Addendum #2

***City of Pearl Parks and Recreation Phase 2:
City Park Improvements
Pearl, MS***

June 12, 2020

2 WALKING TRACK - POLE BASE DETAIL
Scale: NONE

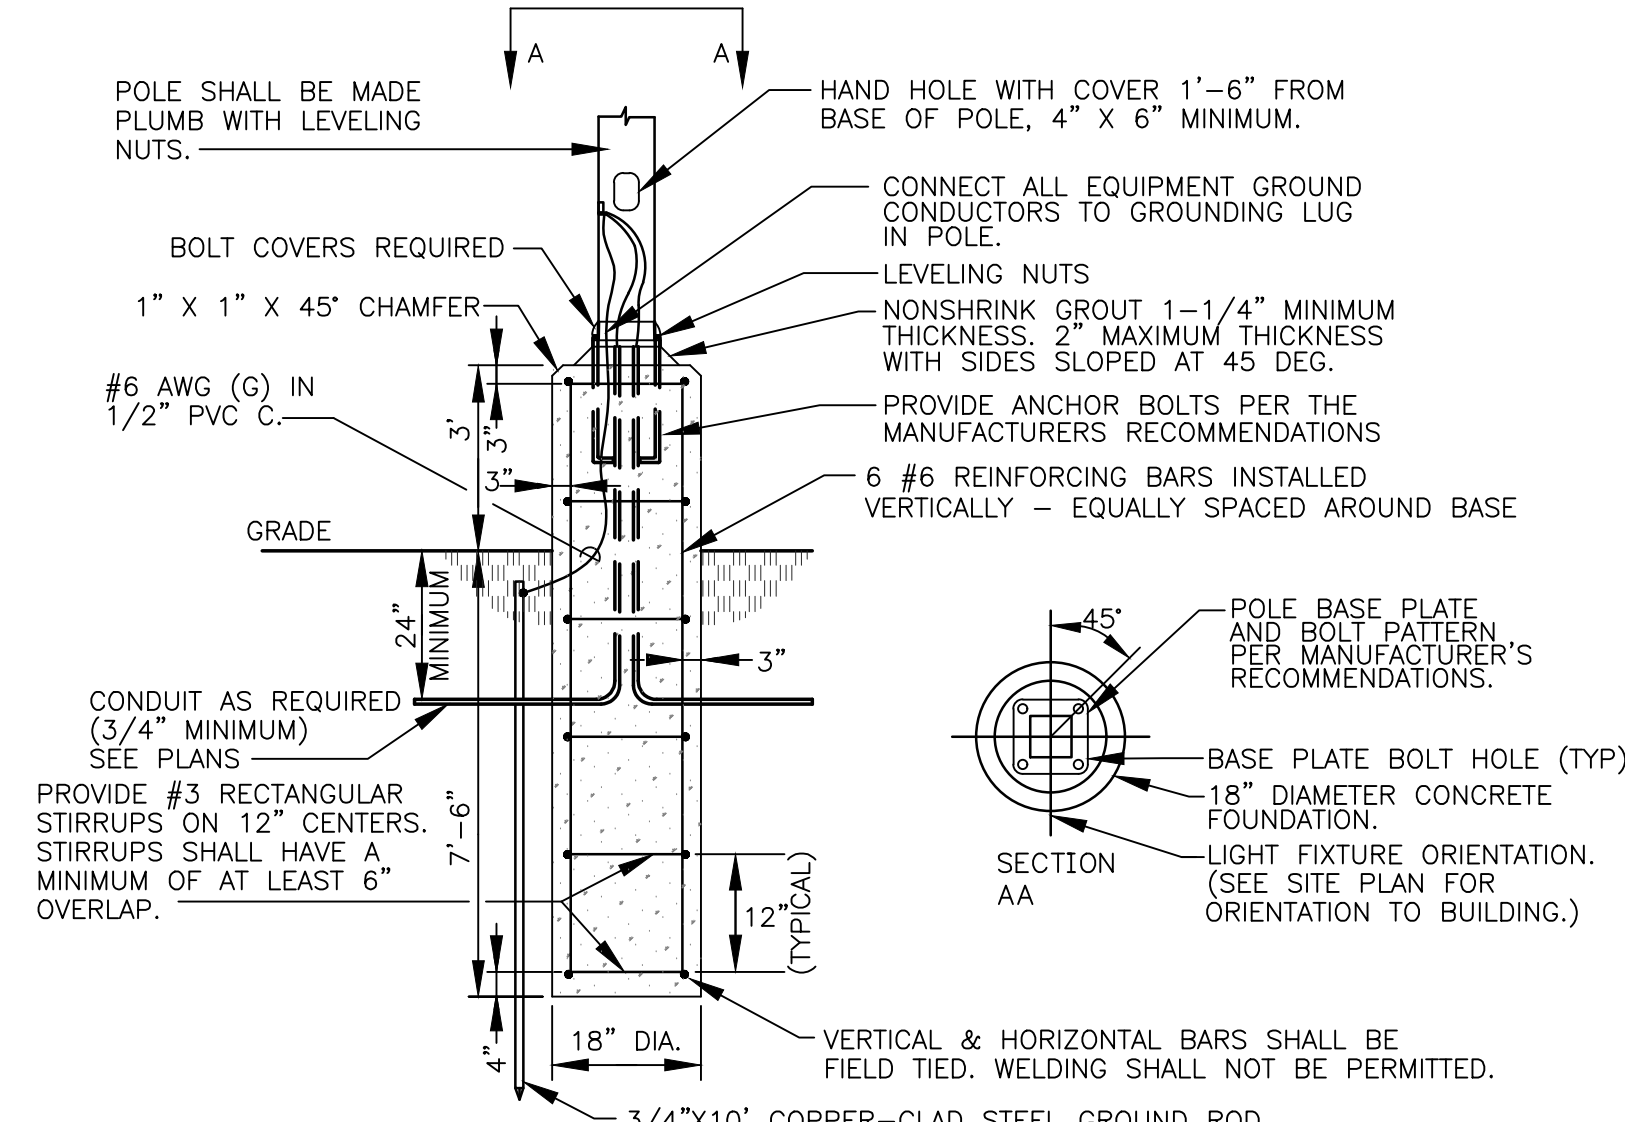
- 3500 PSI MINIMUM 28 DAY COMPRESSIVE STRENGTH CONCRETE WITH GRADE 60 RE-BARS.
- IF WATER IS PRESENT IN HOLE, REMOVE BEFORE POURING CONCRETE.
- FOUNDATION EXCAVATION SHALL BE BY 24" AUGAR IN UNDISTURBED OR PROPERLY COMPACTED FILL.
- MINIMUM ALLOWABLE SOIL BEARING PRESSURE 3000 PSF. NOTIFY ENGINEER IF BEARING PRESSURE IS LESS.
- AIR ENTRAINMENT: 4 TO 6%.

E.O.1

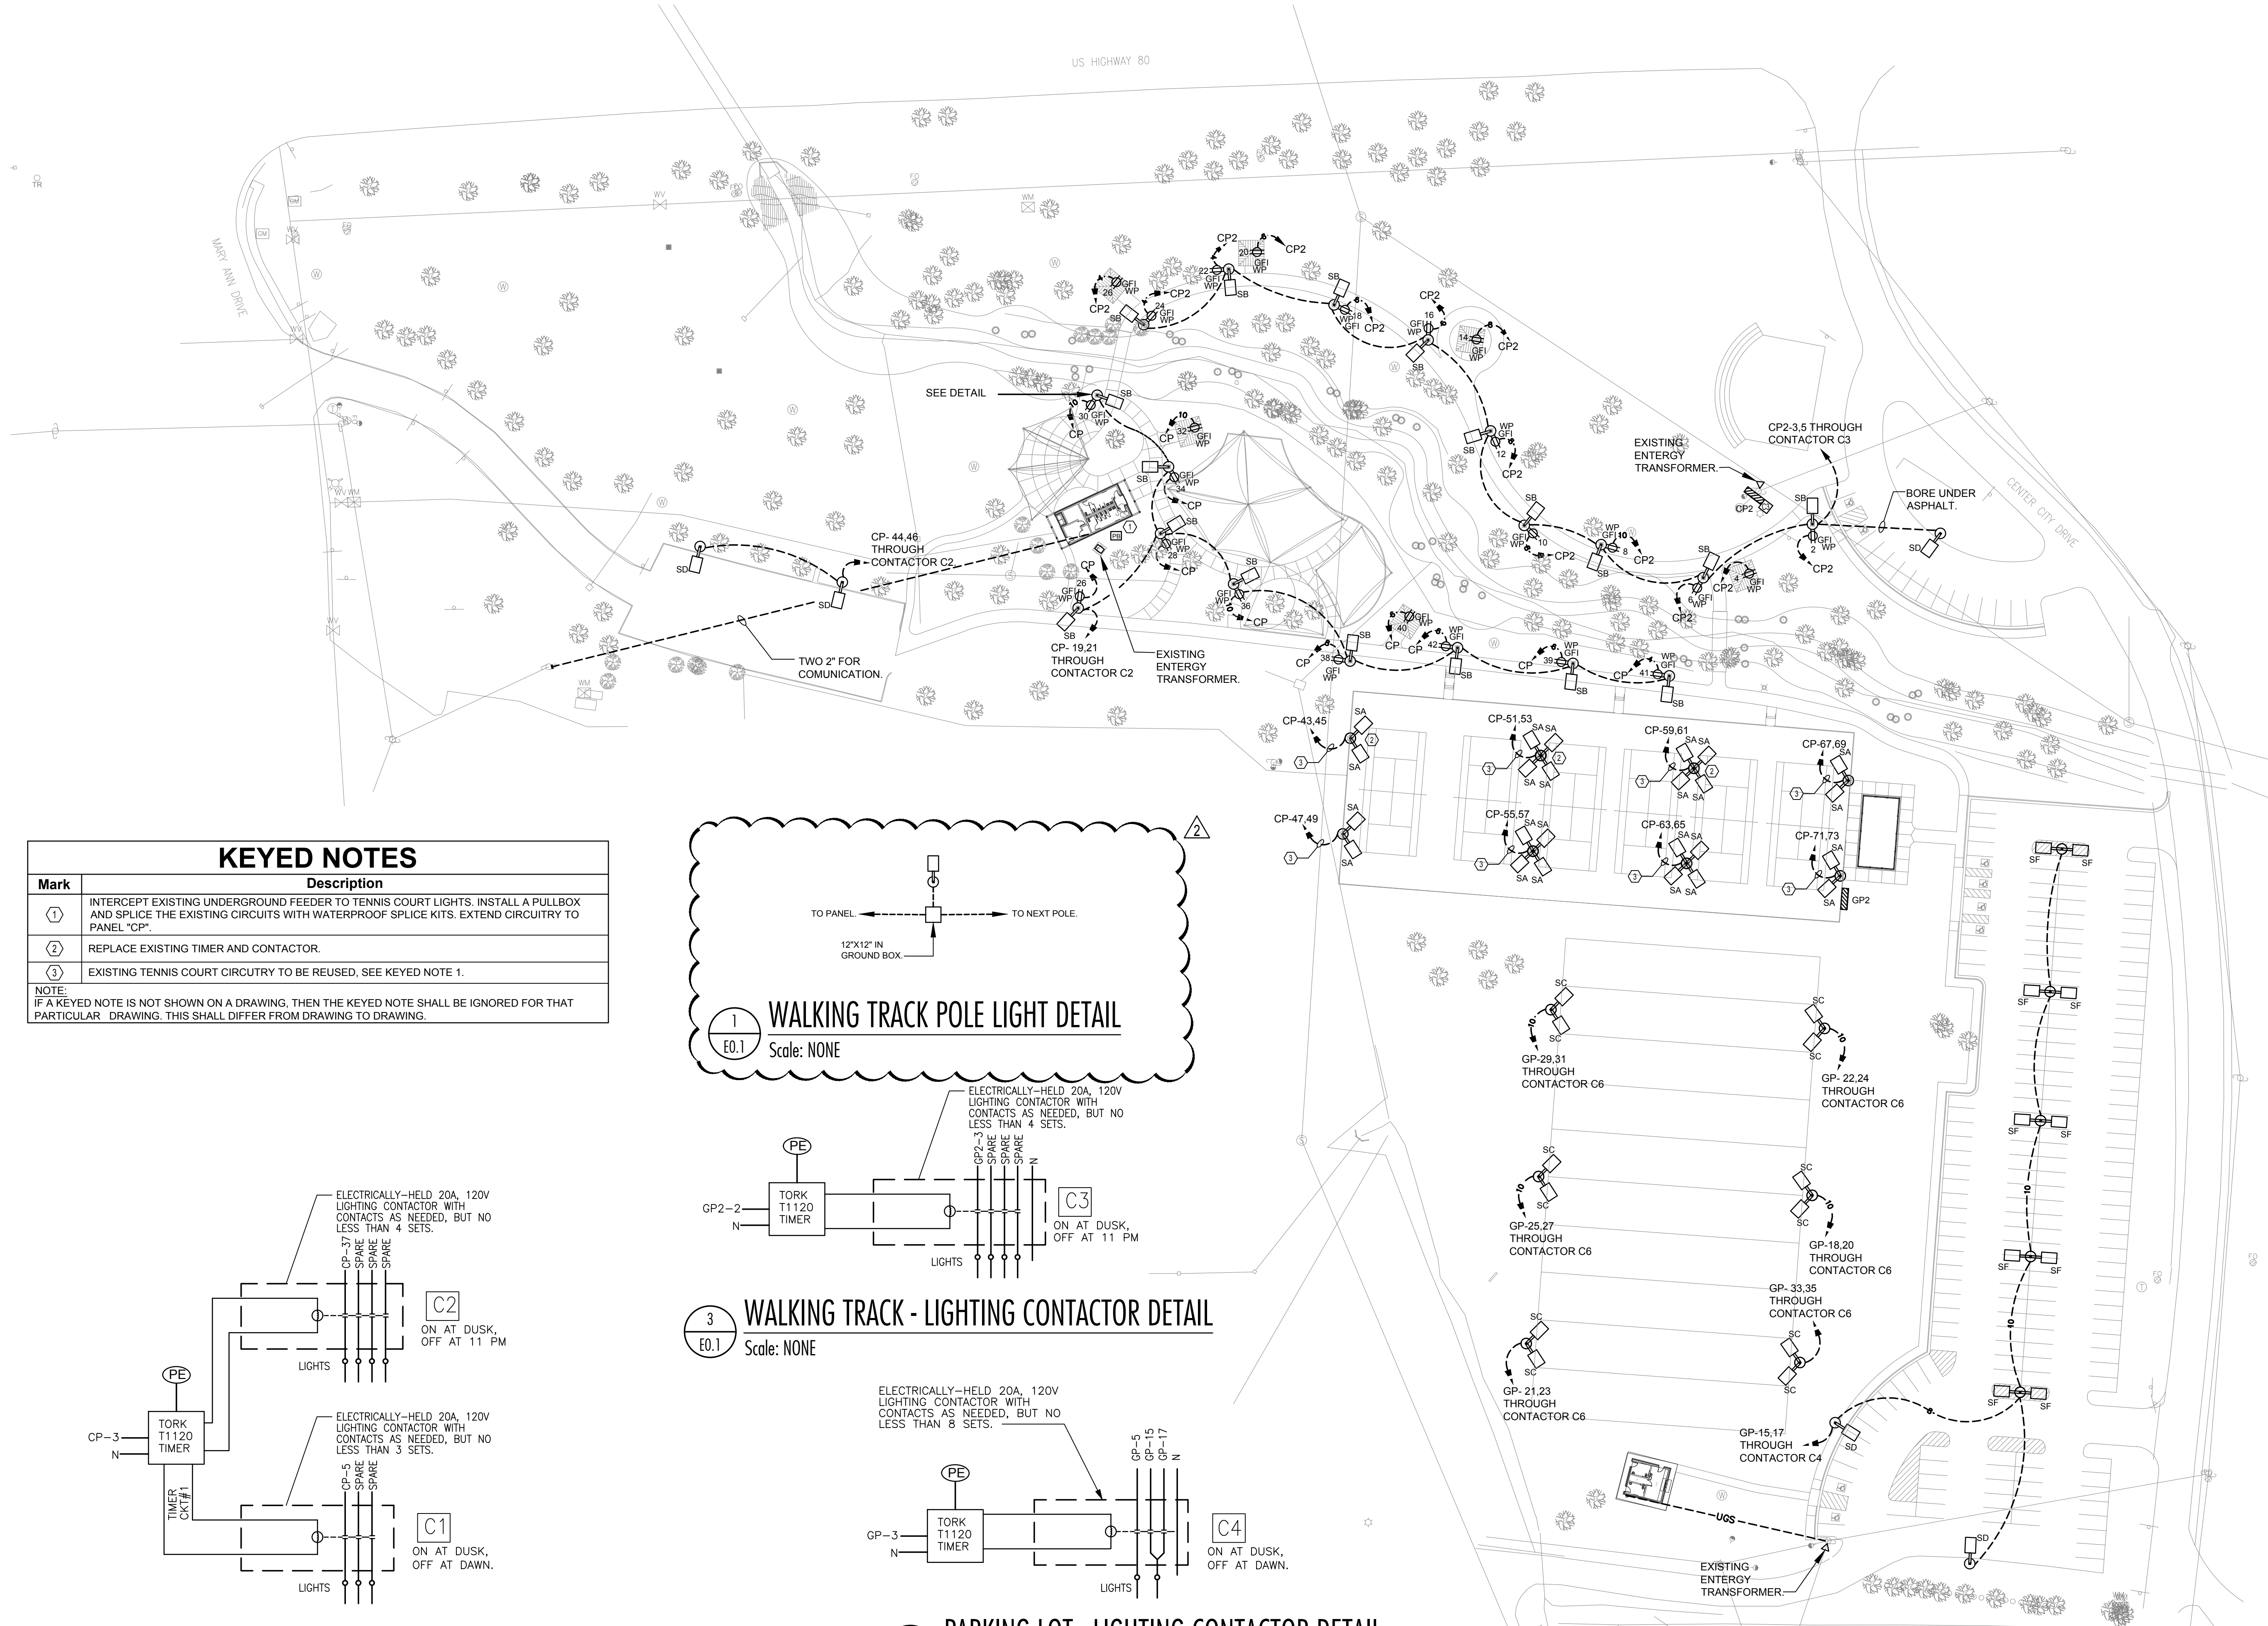
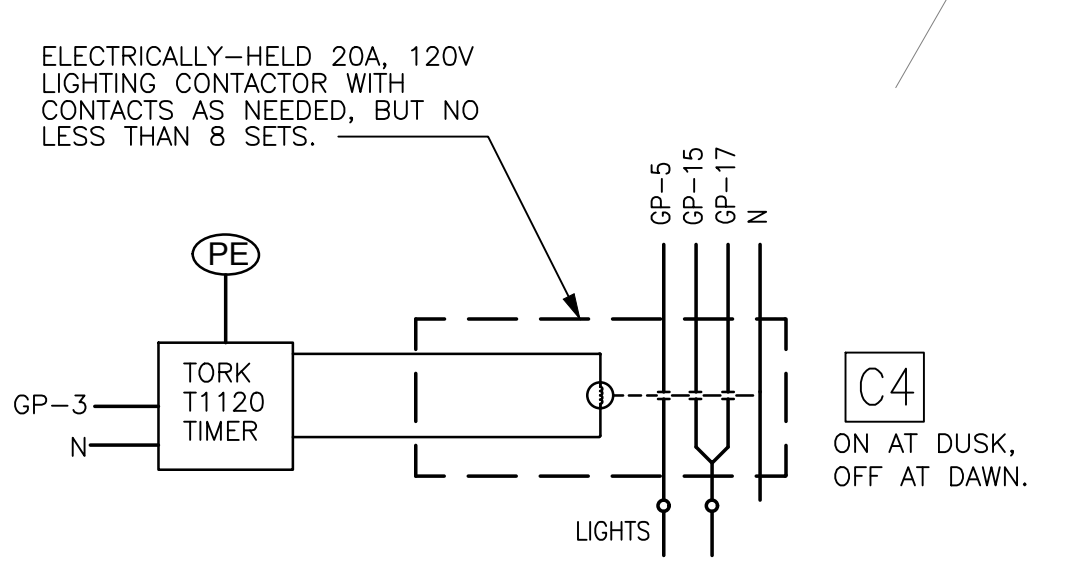
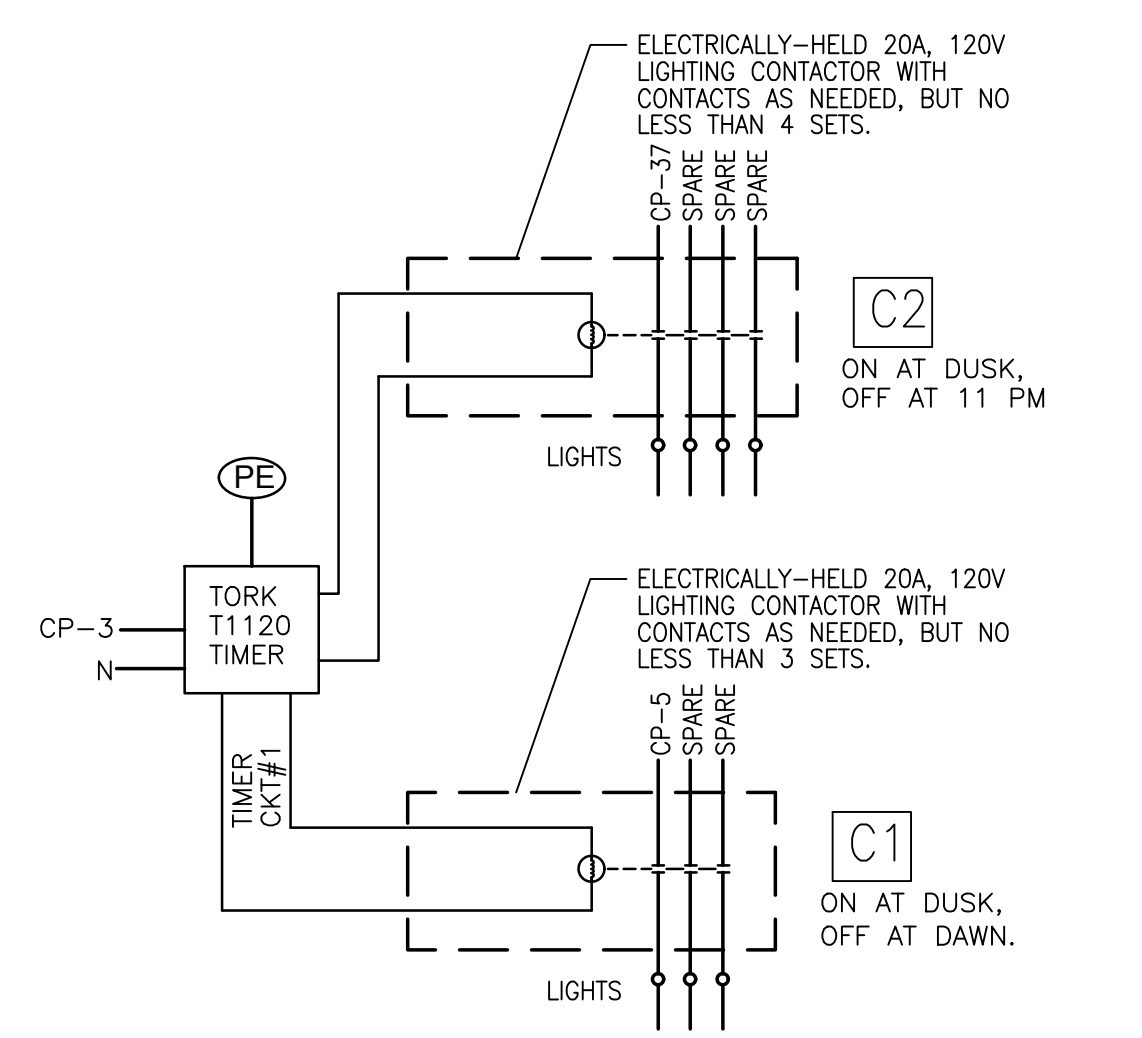
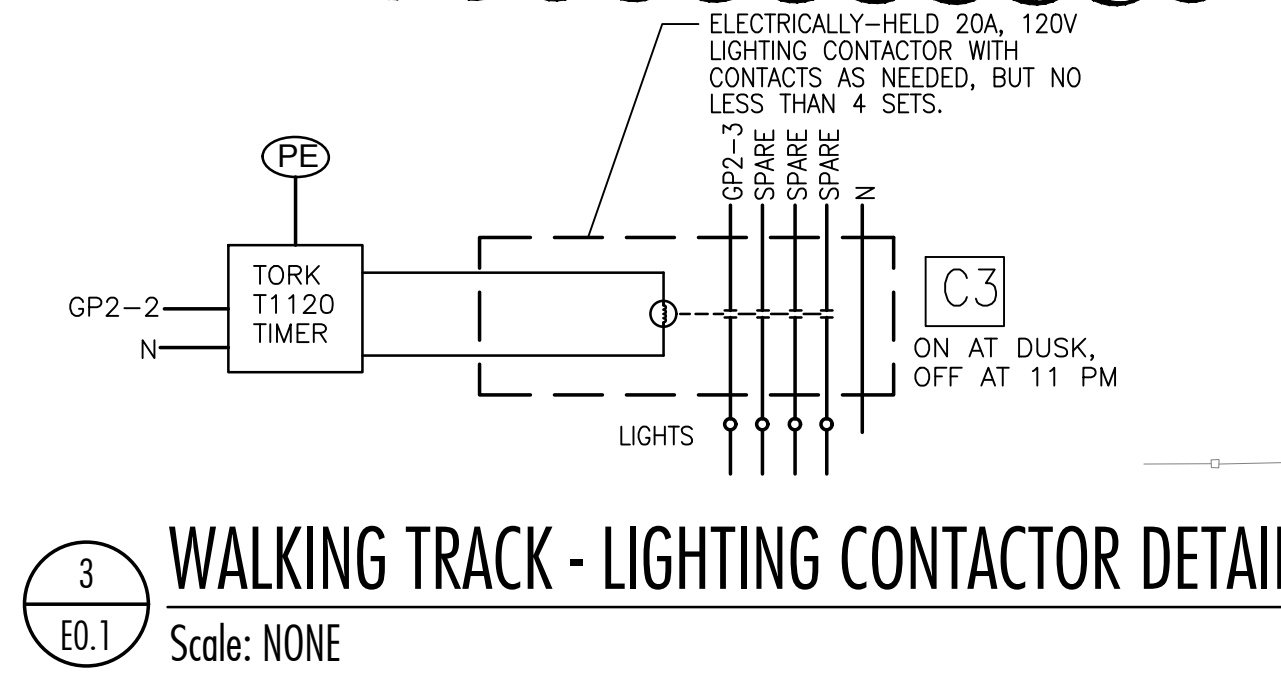
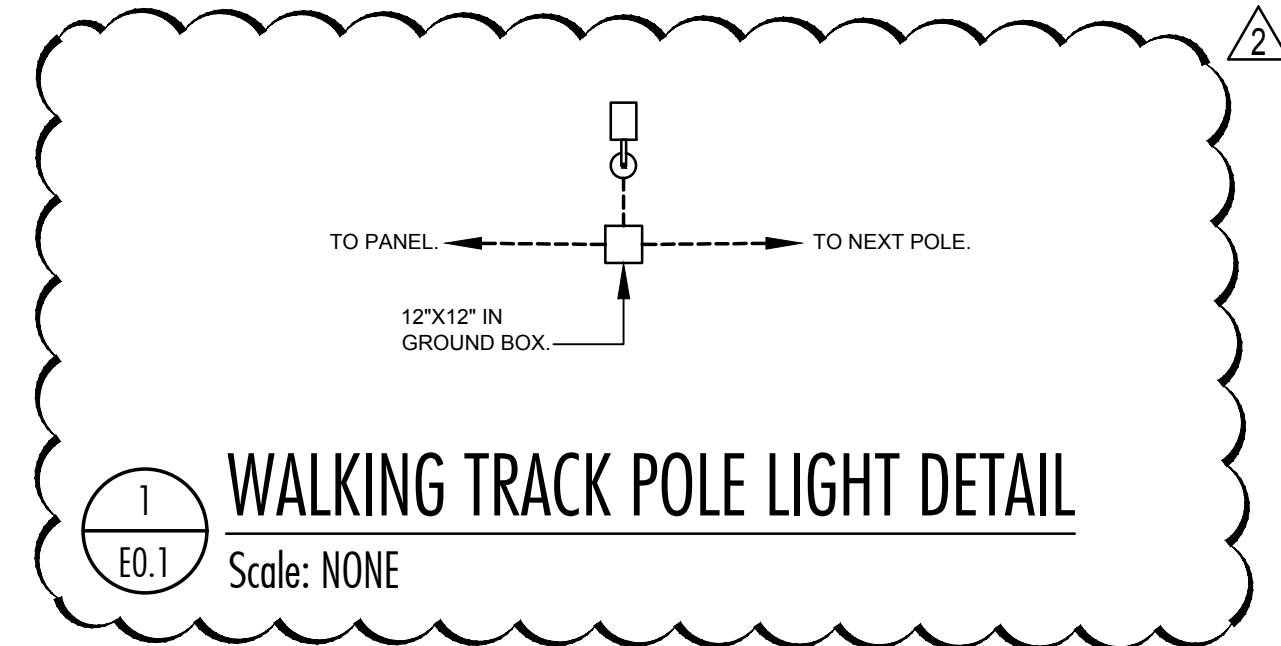
KEYED NOTES	
Mark	Description
①	INTERCEPT EXISTING UNDERGROUND FEEDER TO TENNIS COURT LIGHTS. INSTALL A PULLBOX AND SPLICE THE EXISTING CIRCUITS WITH WATERPROOF SPLICE KITS. EXTEND CIRCUITRY TO PANEL "CP".
②	REPLACE EXISTING TIMER AND CONTACTOR.
③	EXISTING TENNIS COURT CIRCUITRY TO BE REUSED. SEE KEYED NOTE 1.

Mark	Description
①	REPLACE EXISTING DISCONNECT WITH A NEMA 3R PANEL NN2.
